Access Compliance Report Public Rights-of-Way (Curb Ramps)

Intersection ID: 19731 Main Street: ARUNDEL DR **Cross Street: WINTERCREST LN** Location: S ADA ID: DB4A0DD7926B Ramp Type: Directional1 Initial Pass/Fail: Fail **Overall Compliance: No Severity Score:** 1.25

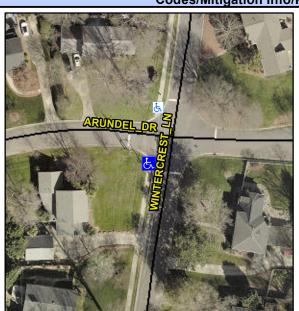
Field Measurements/Component Compliance					
Compl	iance Description	Data	Compl	iance Description	Data
N/A	Ramp Length (in)	62.0	N/A	Grade Break?	N/A
Yes	Ramp Width (in)	61.0	N/A	Grade Break Slope (%)	0.0
Yes	Ramp Slope (%)	4.9	N/A	Grade Break XSlope (%)	0.0
No	Ramp XSlope (%)	2.3			
N/A	Flare Type LT	N/A	N/A	Flare Type RT	N/A
N/A	Flare Slope LT (%)	N/A	N/A	Flare Slope RT (%)	0.0
N/A	Flare Traversable LT?	N/A	N/A	Flare Traversable RT?	N/A
N/A	Landing Length (in)	0.0	N/A	DWS Provided?	N/A
N/A	Landing Width (in)	0.0	N/A	DWS Contrast?	N/A
N/A	Landing Slope (%)	0.0	N/A	DWS Length (in)	N/A
N/A	Landing X Slope (%)	0.0	N/A	DWS Full Width?	N/A
N/A	Landing Curb? (Y/N)	N/A	N/A	DWS Offset LT (in)	N/A
N/A	Shared Landing?	N/A	N/A	DWS Offset RT (in)	N/A
N/A	Gutter Ponding?	0.0	N/A	Gutter Slope (%)	N/A
N/A	Gutter Lip Ht (in)	0.0	N/A	Gutter X Slope (%)	N/A
N/A	Painted X Walk1?	No		Road Slope (%)	2.0
	X Walk 1 Direction	To N		Road X Slope (%)	2.9

Possible Solutions: Remove & Replace Entire Ramp. Surveyor Notes: N/A PROW/ADA: R304.5.3
